MEMORANDUM

From: Steve Long  
To: Jean Fraser, Planner  
Date: December 4, 2012  
Subject: Commercial & Maple Street Mixed Use Development – Responses to Comments

RE: Response to Traffic Comments  
Applicant - J. B. Brown & Sons  
Proposed Hotel, Restaurant, and Residences  
321 Commercial Street, Portland, Maine  
MMI #5002-01-4

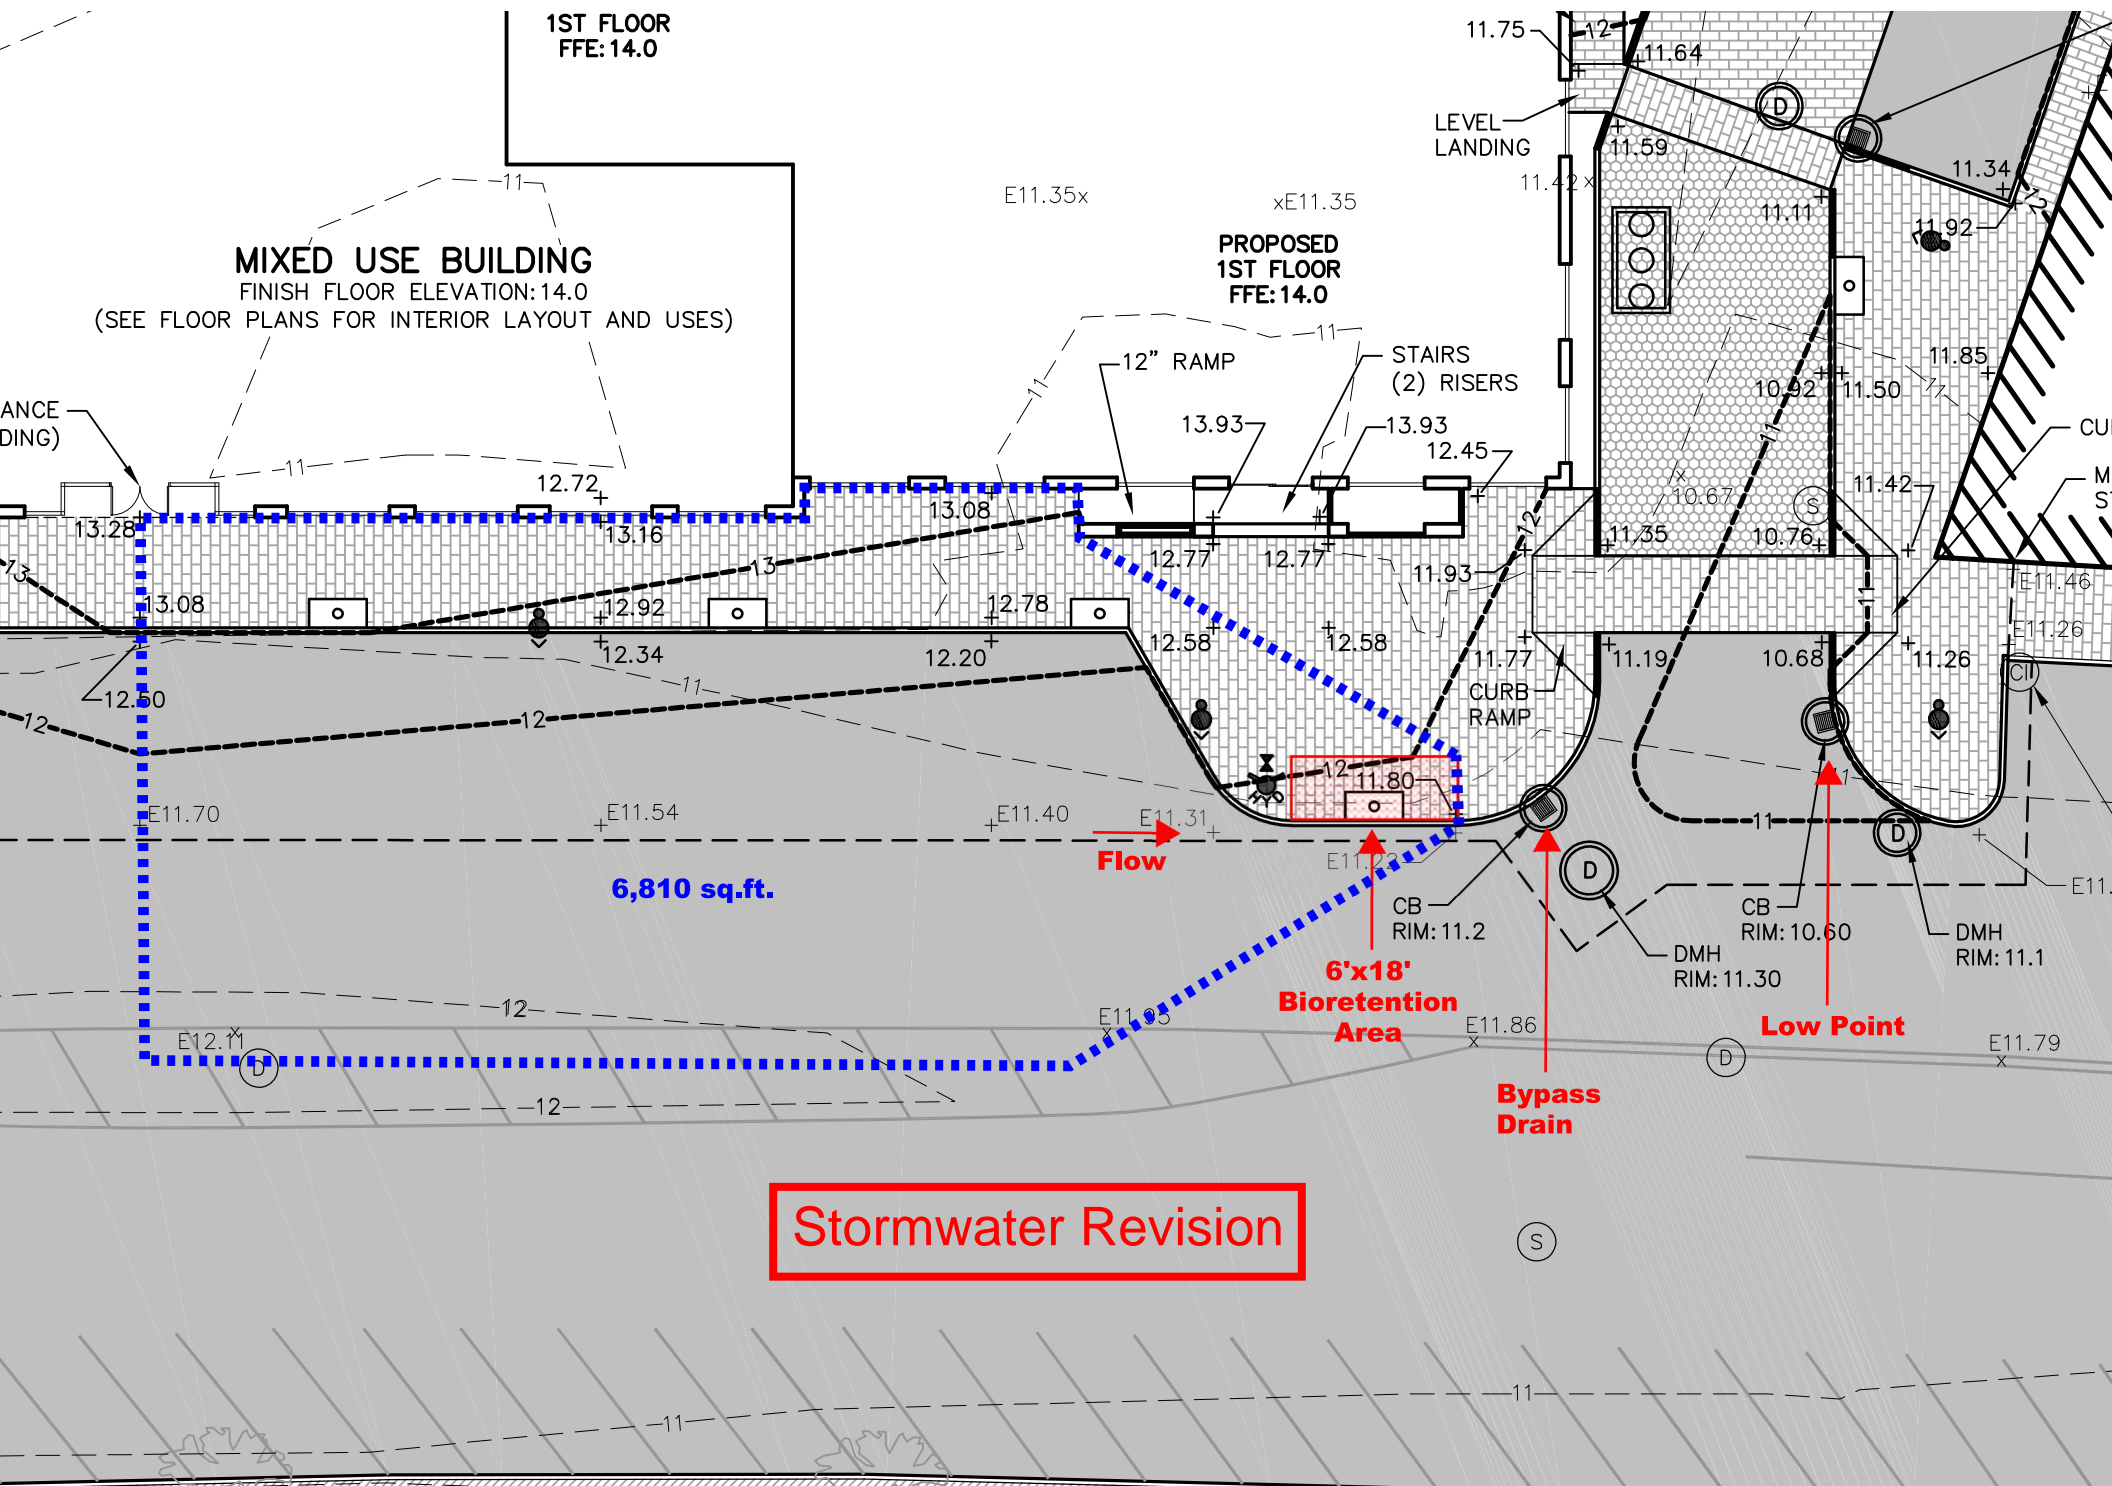
*Comment: The applicant should provide additional supporting data for use of the 0.65 parking rate for the hotel.*

Response: The applicant is basing the 0.65 parking demand rate on several sources of parking demand data, including:

- Hilton Worldwide parking demand rate of 0.65 spaces per occupied room: Experience from data provided by Hilton Worldwide indicates that urban hotel properties generate approximately two customer vehicles per three occupied rooms (0.65 vehicles per occupied room). This is attributable to the fact that

some guests arrive by taxi, hotel courtesy van, or other means of public transportation. Further, some guests (such as families or business groups) will arrive in a single vehicle but occupy more than one room. During full occupancy, a 0.65 vehicles/room ratio would be expected to generate approximately 86 guest vehicles. This is consistent with the approval of the Jordan's Meats site proposed hotel which utilized the 0.65 rate.

- ITE Parking Generation Manual, 4<sup>th</sup> Edition: We have reviewed data available for Land Use Code 310, for Hotels, from the Manual. On page 73 of this Manual, Hotels in urban sites are specifically discussed. Parking demand data for 5 urban sites were reviewed and indicated a weekday average peak parking demand of 0.64 vehicles per occupied room. Based on this rate the proposed 131 room hotel would require 84 parking spaces. In our original parking study for the site we referenced the 0.65 rate from Hampton Worldwide data, noted in Item 1 above. Use of the ITE rate of 0.64 would result in 2 less spaces being provided.

The two methodologies result in nearly identical parking requirements (86 spaces, compared to 84 spaces), however both are substantially higher than the City ordinance, 14-332(c), which would require only 33 spaces based on a rate of 0.25 spaces per room.

Based on this updated parking demand analysis, we recommend utilizing the 86 hotel spaces determined in our original parking demand analysis submission.
